**Re: Response to Council Interrogatories  
PETITION NO. 1592A - Santa Fuel, Inc. petition for a declaratory ruling,  
pursuant to Connecticut General Statutes §4-176 and §16-50k, for the  
proposed construction, maintenance and operation of a 3.575-megawatt AC  
solar photovoltaic electric generating facility located at the 159 South Road,  
Somers, Connecticut, and associated electrical interconnection.**

**RESPONSES TO THE DECEMBER 17, 2024 PRE-HEARING INTERROGATORIES  
DIRECTED TO SANTA FUEL, INC. FROM THE CONNECTICUT SITING COUNCIL**

**ATTACHMENT 1**  
**Revised Sight Line Demonstration Plan**

**Mountain View Rd  
Access Drive  
Sight Line  
Demonstration Plan**

Sight Line Criteria  
Posted/Design Speed: 30mph  
Required Sight Distance: 335 feet

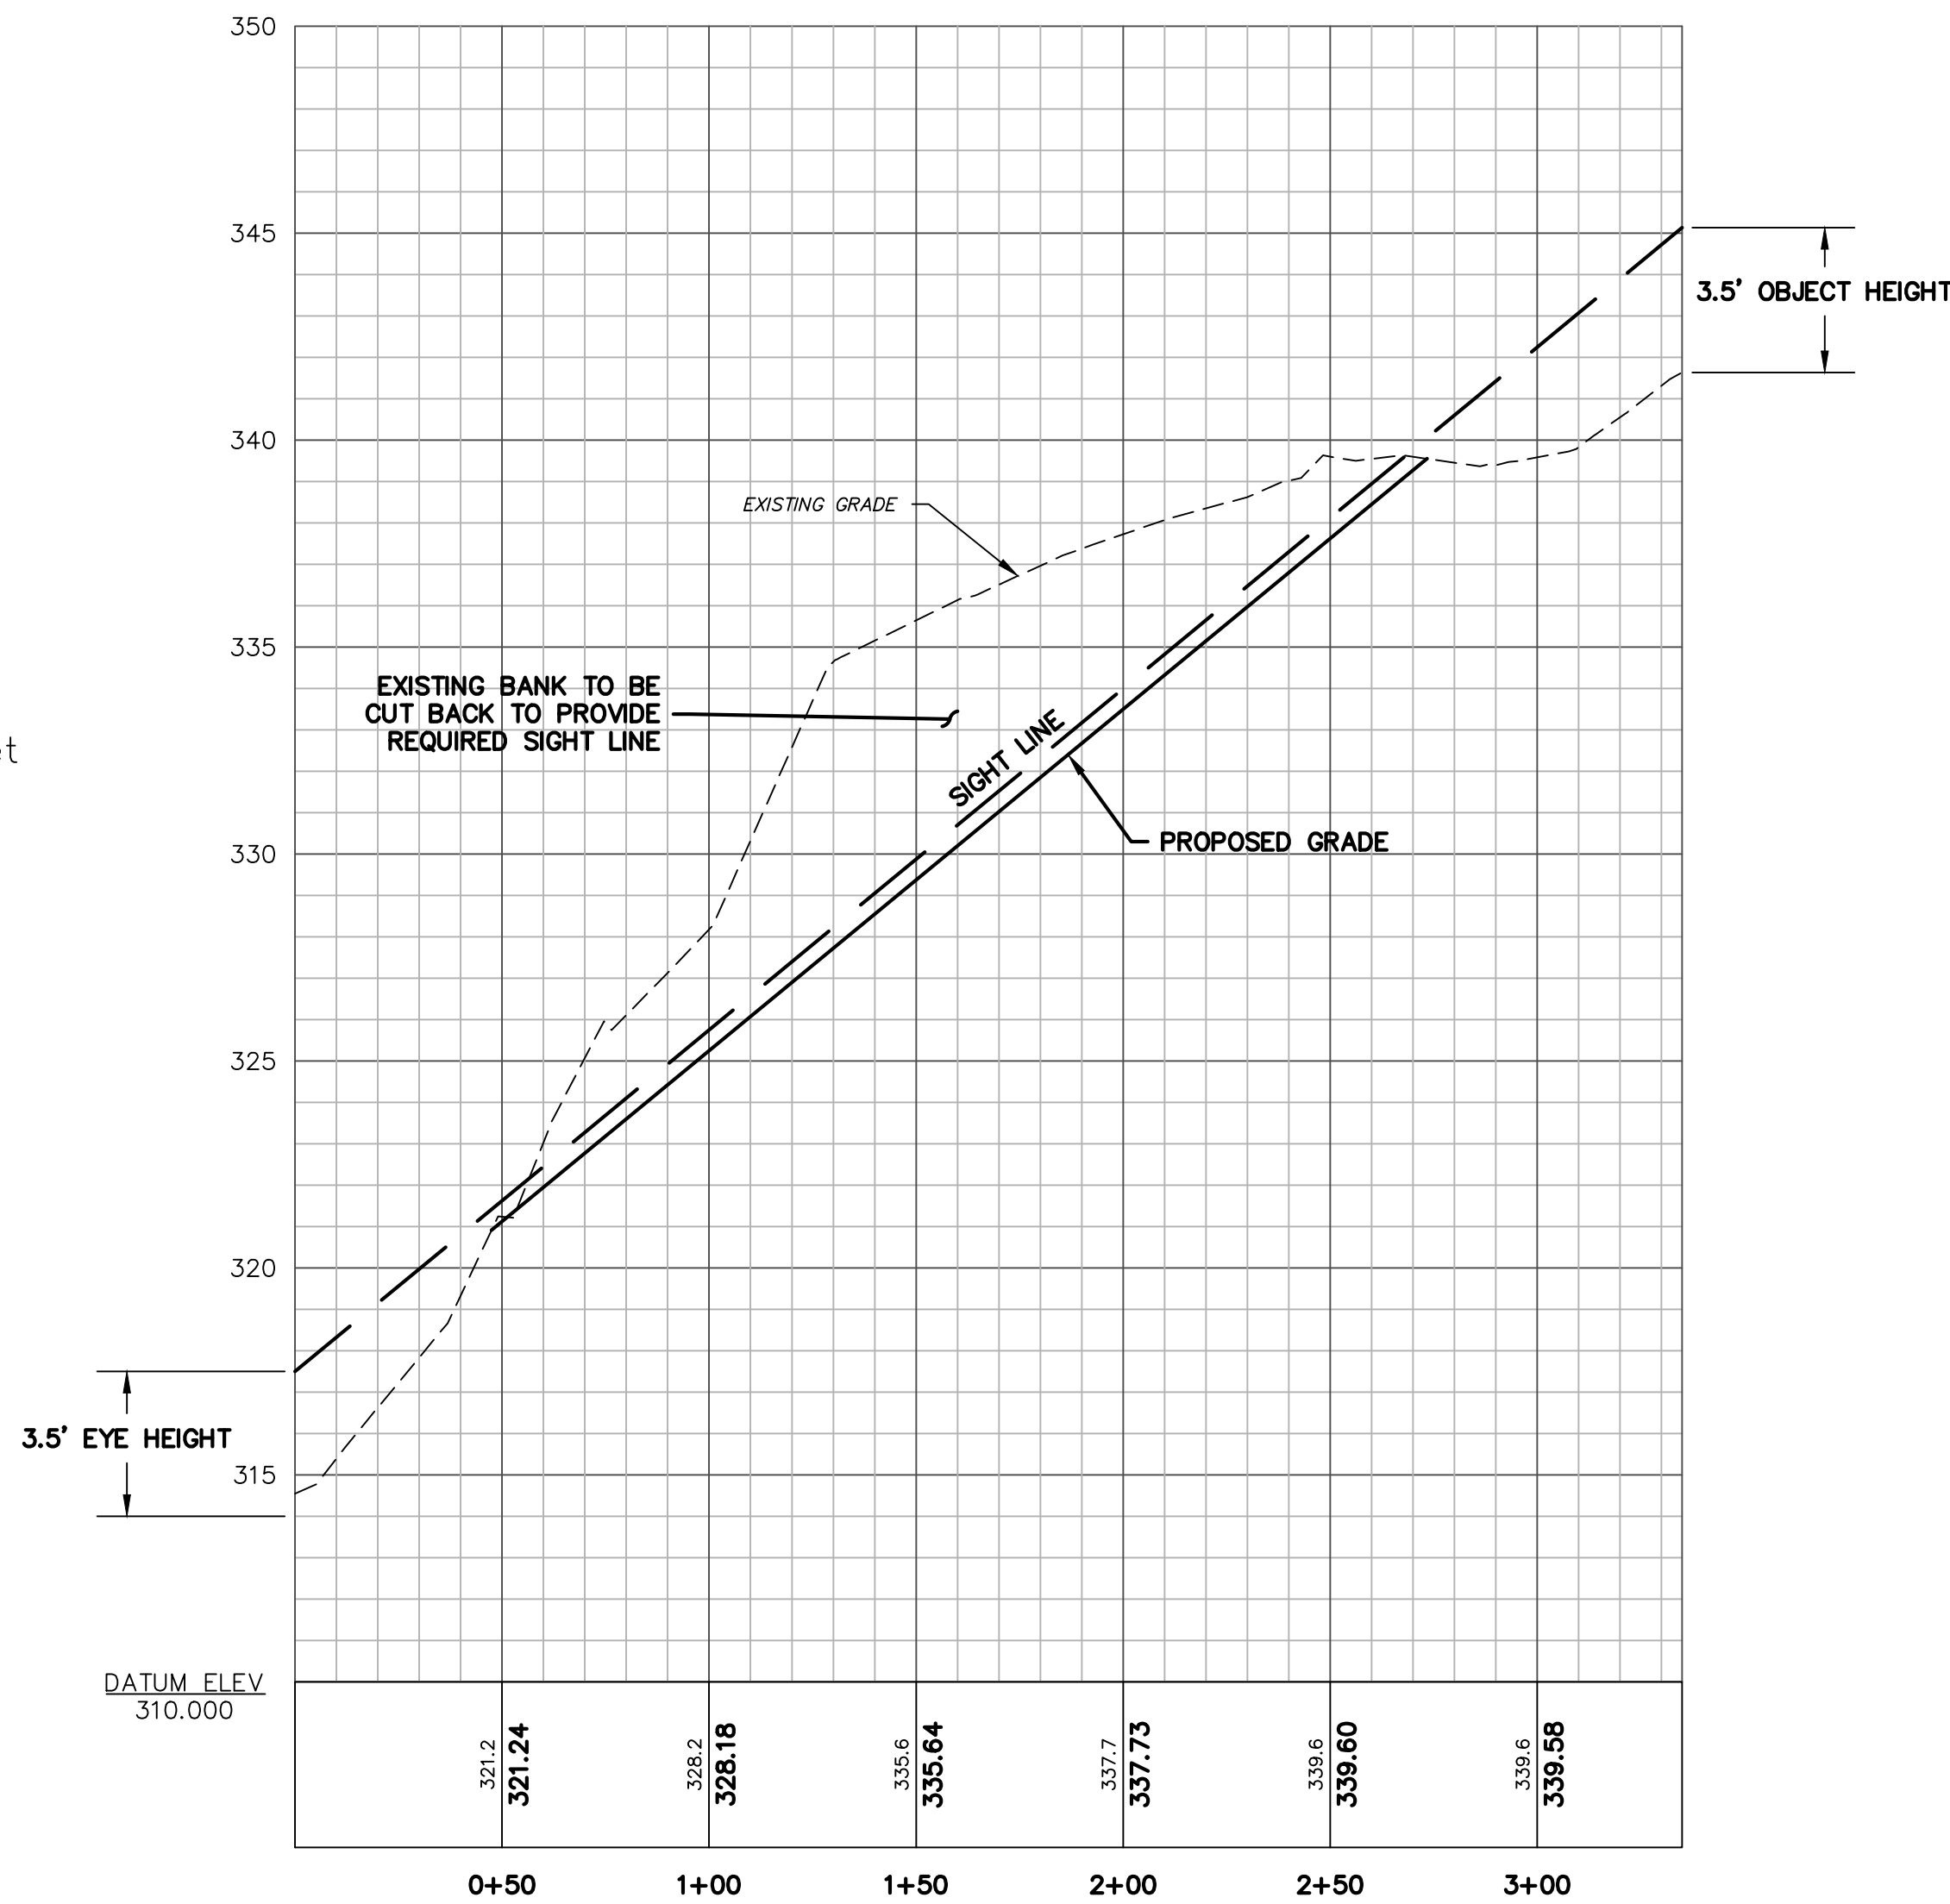
13. Referencing Motion to Reopen p. 4 and the Sight Line Demonstration Plan behind Attachment A, what is the basis for the standards that were used for the sight line criteria (ex. Connecticut Department of Transportation requirements, Eversource Energy requirements)?

- A. The required sight distance was calculated in accordance with the Connecticut Department of Transportation Highway Design Manual procedures for intersection sight distance (ISD). A revised Sight Line Demonstration Plan is provided as Attachment 1. Upon review, it was determined that the slope factor adjustment applied to the initial ISD calculation is not warranted. The plan was revised to provide the correct ISD criteria. The revised Plan indicates that the required ISD is still provided at the proposed driveway. However, the revision resulted in a reduction in the size of the Easement required across the property at 23 Mountain View Road.
